**UPDATE CHANGE NOTIFICATION # 16642**Generic Copy

**TITLE:** Update Notification to FPCN16642 for Qualification of SOT23 3L, SOT23 5L & SOT23 6L Packages in Assembly and Test Site in LPS (China).

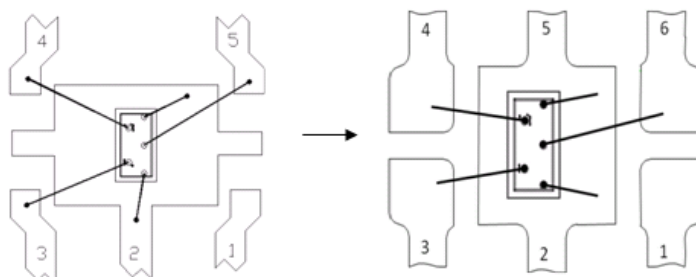
**Package Change & Pin Configuration Change:** The package for SOT23 5L devices will change to SC-74. Pin 5 will be replaced by Pin 6 of SC-74. Pin 5 of the SC-74 will be the same electrical connection as Pin 2.

**Device Marking Change:** The marking for all affected devices will change from 4 characters to 3 characters with the first character being removed.

**Date Code Marking Change:** The date code marking will be changed from YYWW to one digit/alphabet monthly date coding on the device top side.
